MALUHIA, A LONG TERM HEALTH CARE FACILITY
HAWAII HEALTH SYSTEMS CORPORATION

SUBJECT: Addendum No. 1
IFB No. 22M-0324 Maluhia – Dayroom Projects

Addendum No. 1

From: Curtis K. Miyamura
CKM Architects, LLC
Date: April 4, 2022
Re: Drawings and Specifications for Maluhia – Hospital Dayroom Projects
1027 Hala Drive
Honolulu, Oahu, Hawaii
TMK: 1-6-009:004

PARTIAL EXISTING AND DEMOLITION FLOOR PLAN
SCALE: 1/8"=1'-0"

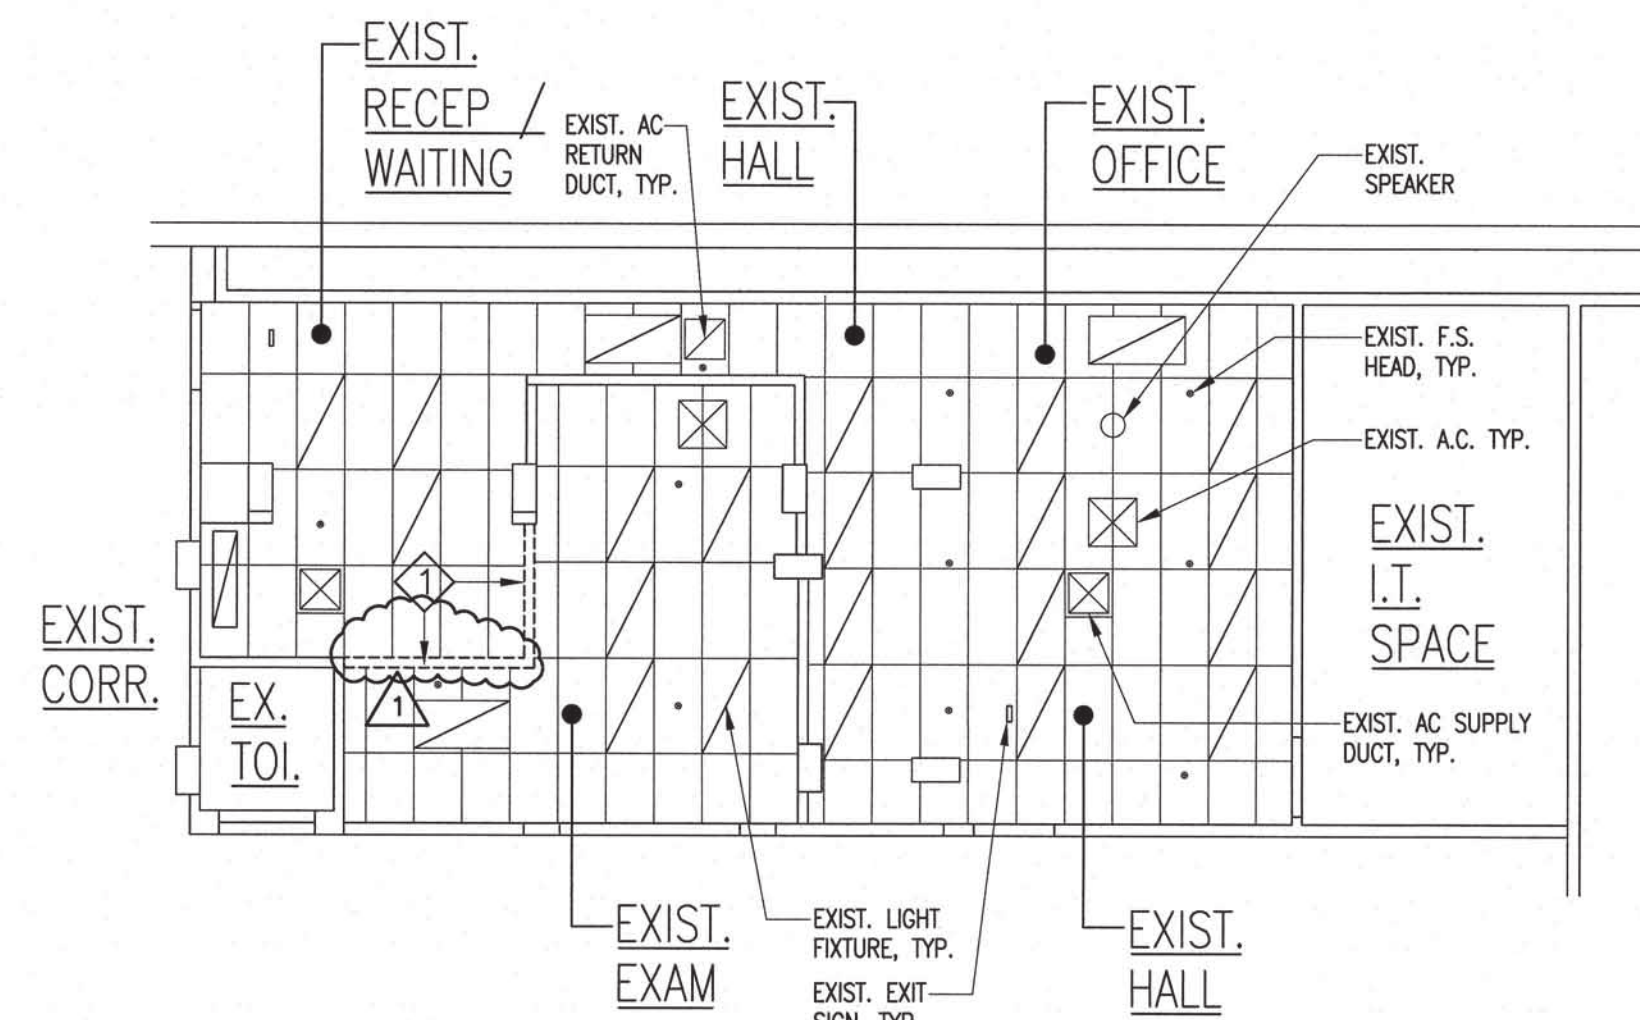
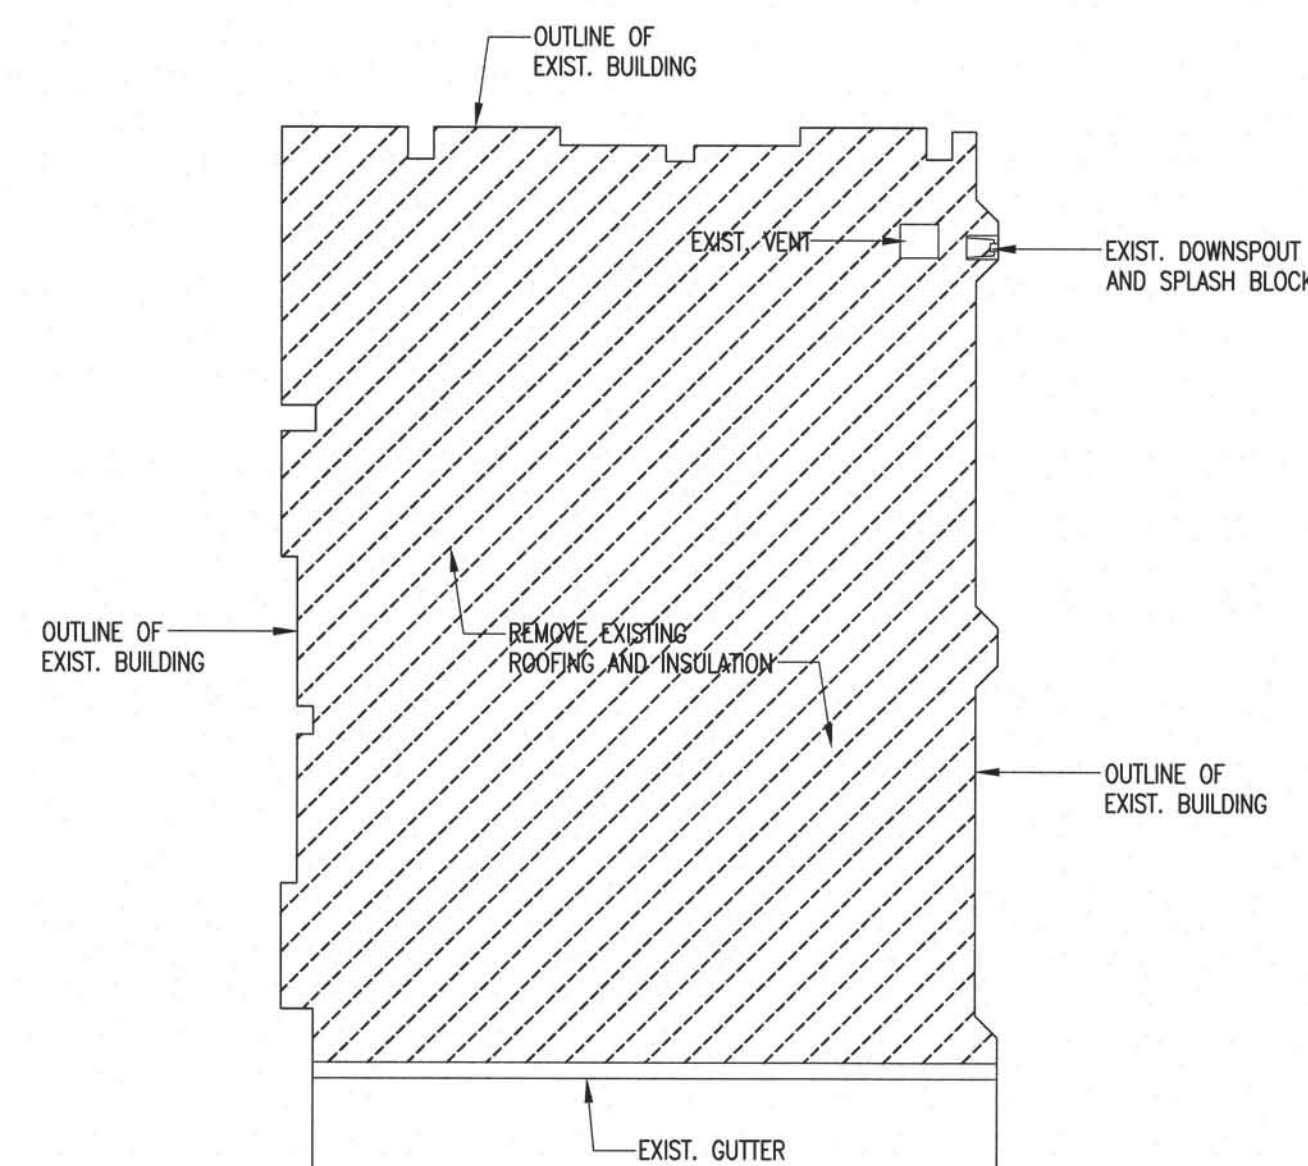
3. Please provide photos:
 - a. Interior locations where door and walls are scheduled for removal? **Refer to Sheet A-1 for demolition plans for Dayroom projects.**

CROSS SECTION, EXTERIOR ELEVATIONS

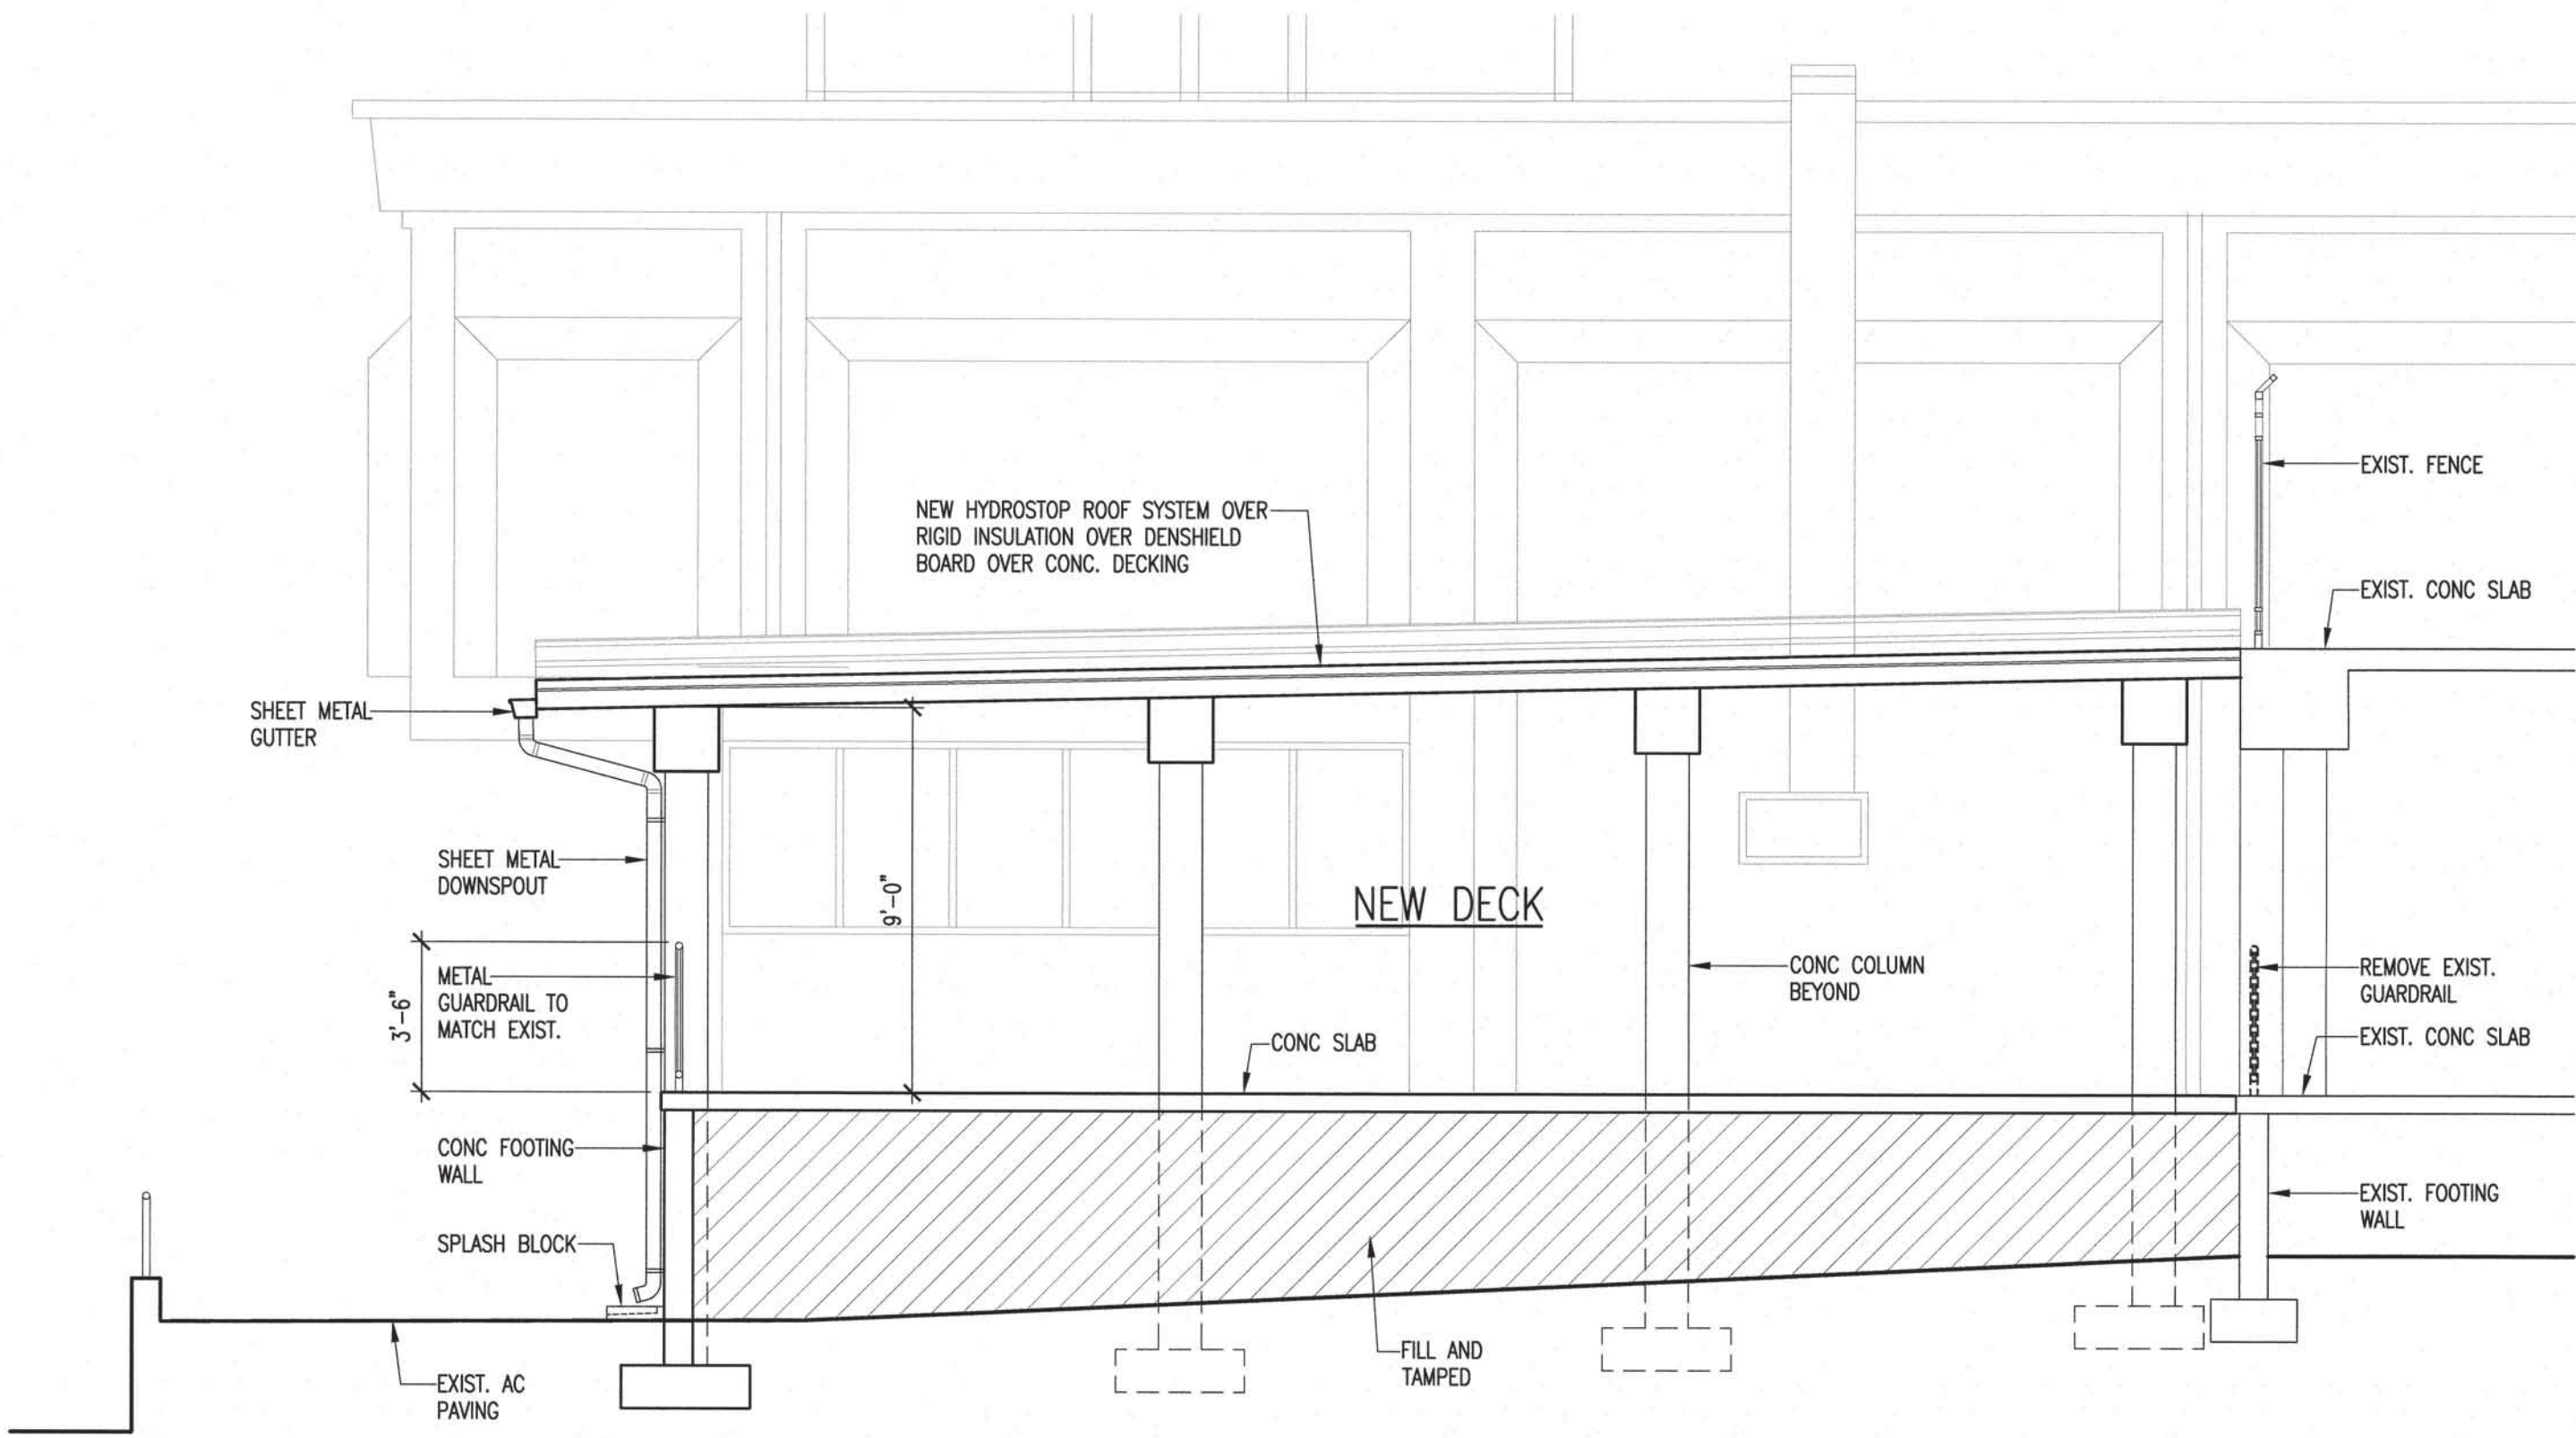
- d. Along the existing building side (west side), the area below the new slab is open to structure below. Please provide details for infilling the open area if the area beneath the new slab is to be filled and tamped per A/A-4.

6. Reference new covered deck area: **Drawings in Addendum 1 addresses the questions for items 6a – 6e.**
 - a. Please provide details for new concrete (footing, slab, columns, beams, suspended roof deck) work (dimensions, reinforcing, etc.)
